April 30, 2018

Subject: ITB #1489-B: Antebellum Way Culvert Replacement – Addendum 1

C-105
Sheet
Bar Measures 1 inch

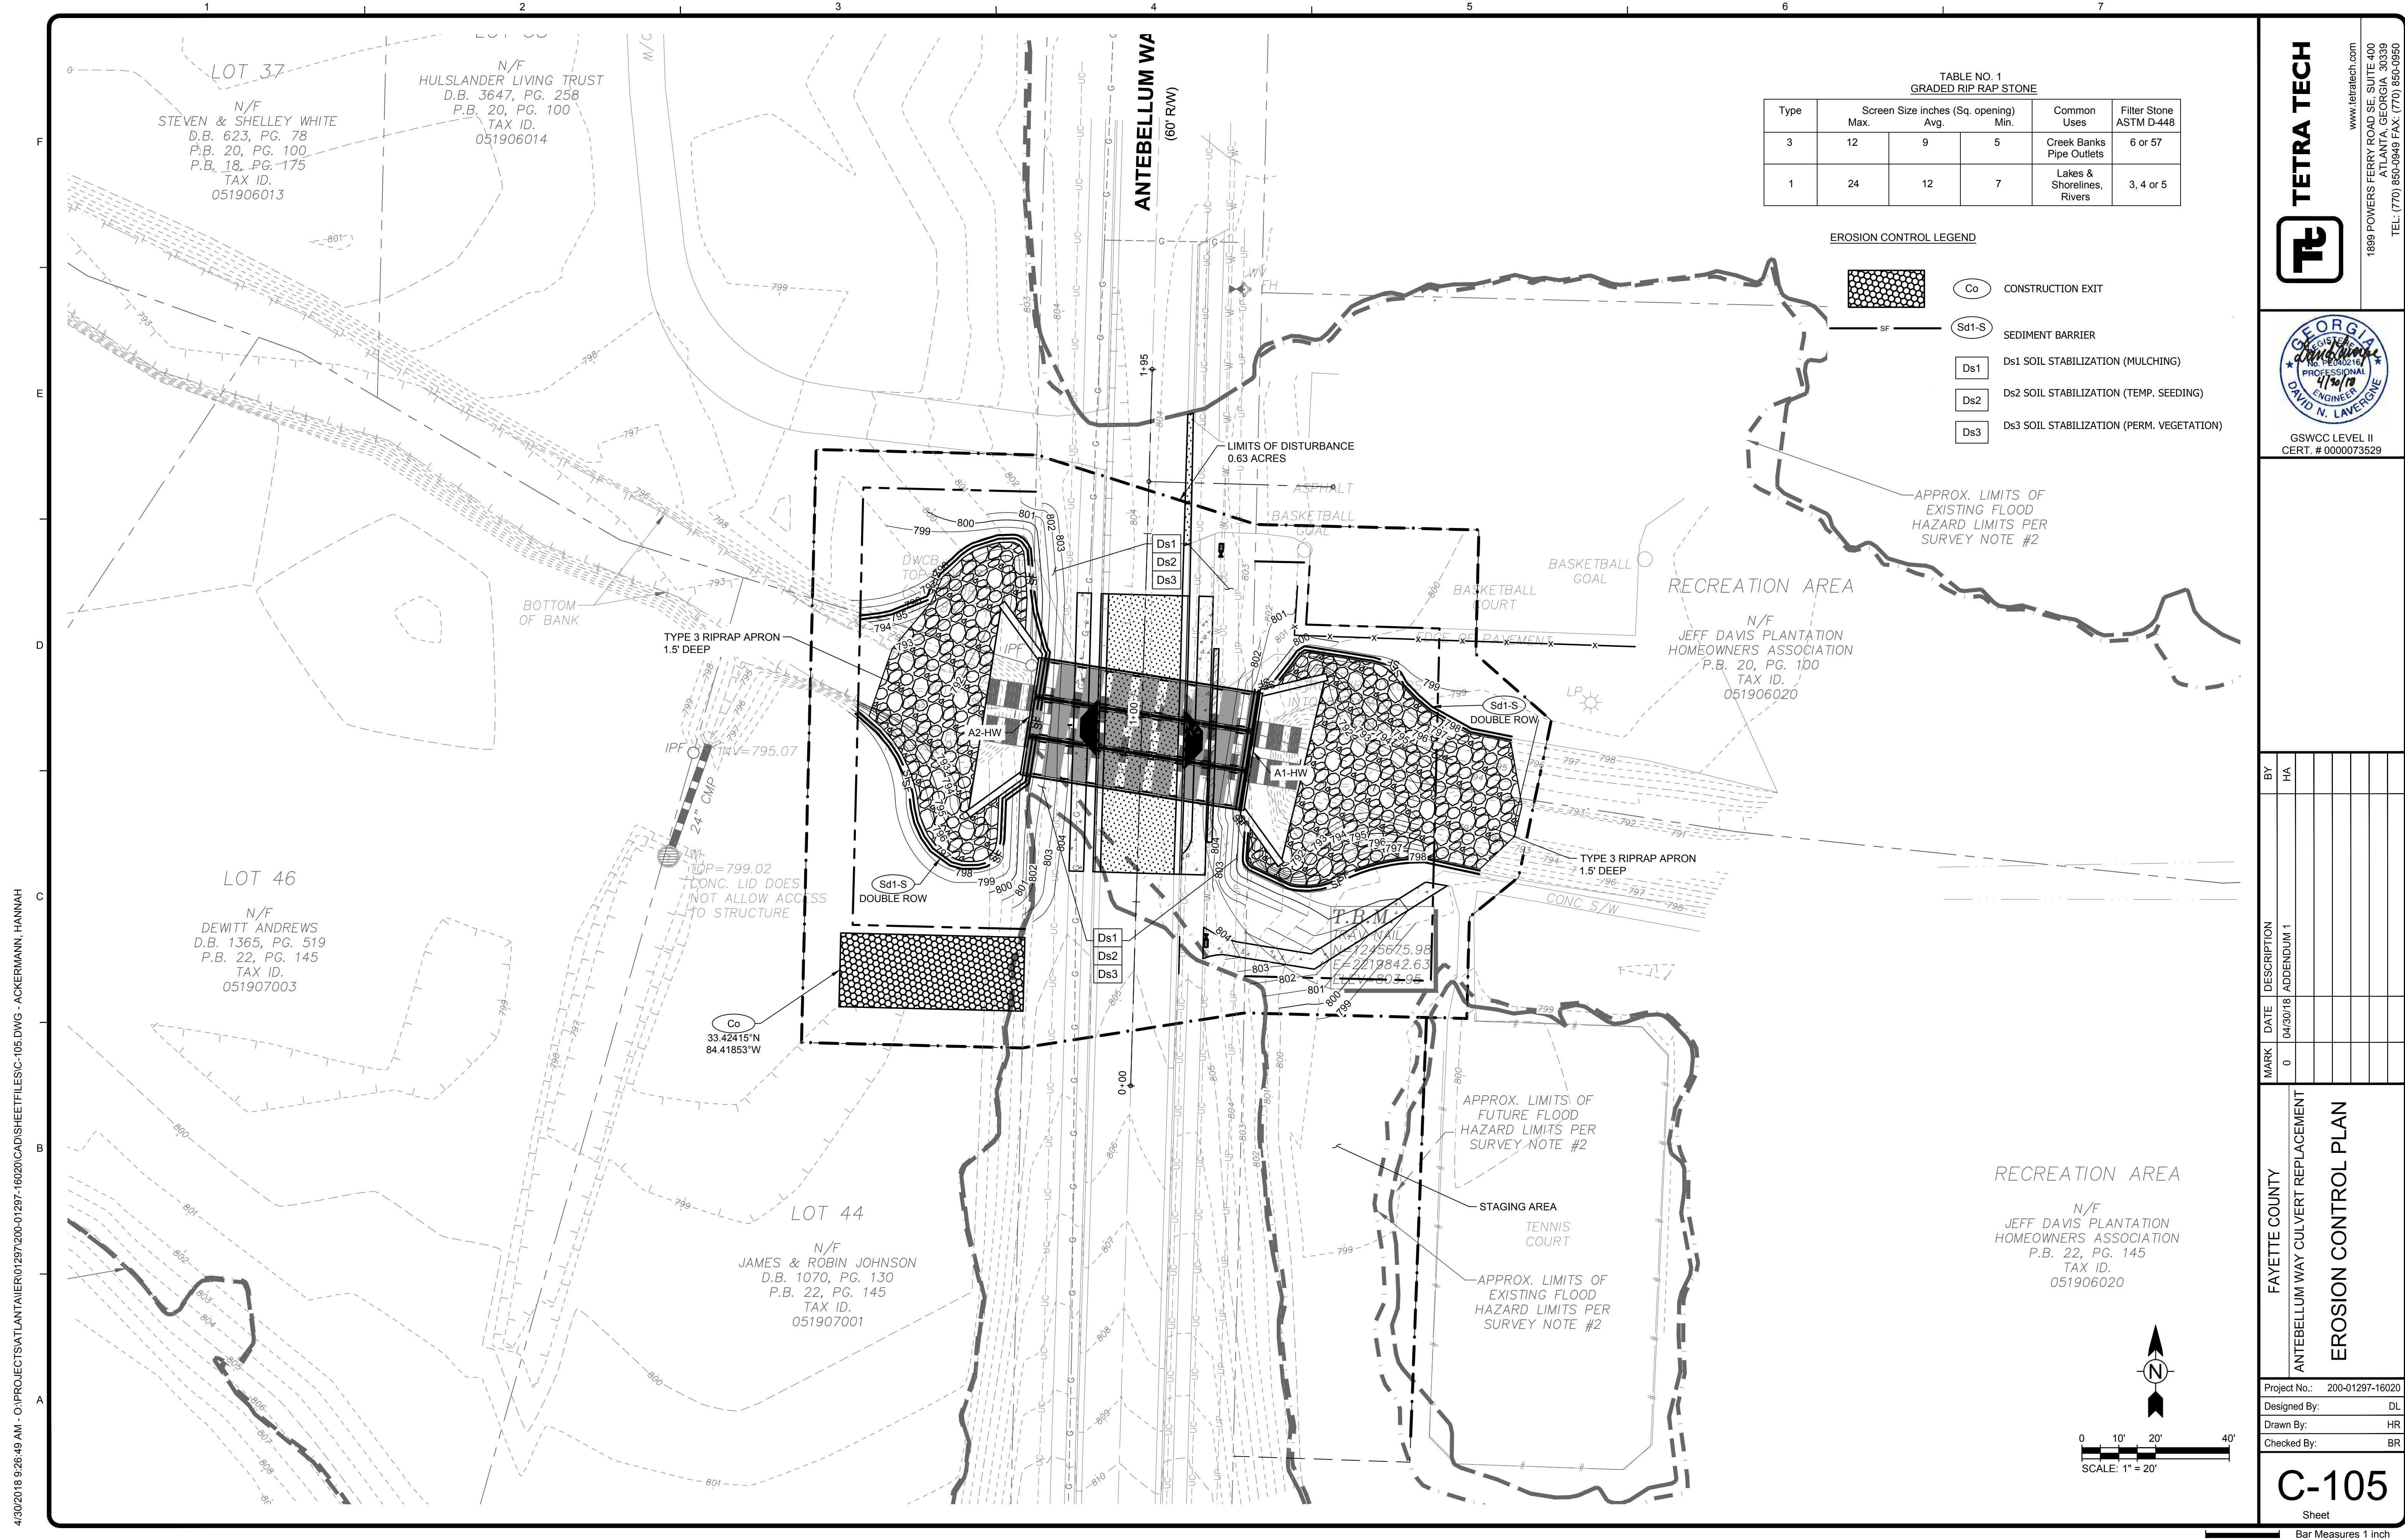
8. There is no erosion control plan. Can you provide that or clarify how Erosion control will be done?

Please find the attached sheet C-105 – Erosion Control Plan which is included in this addendum.
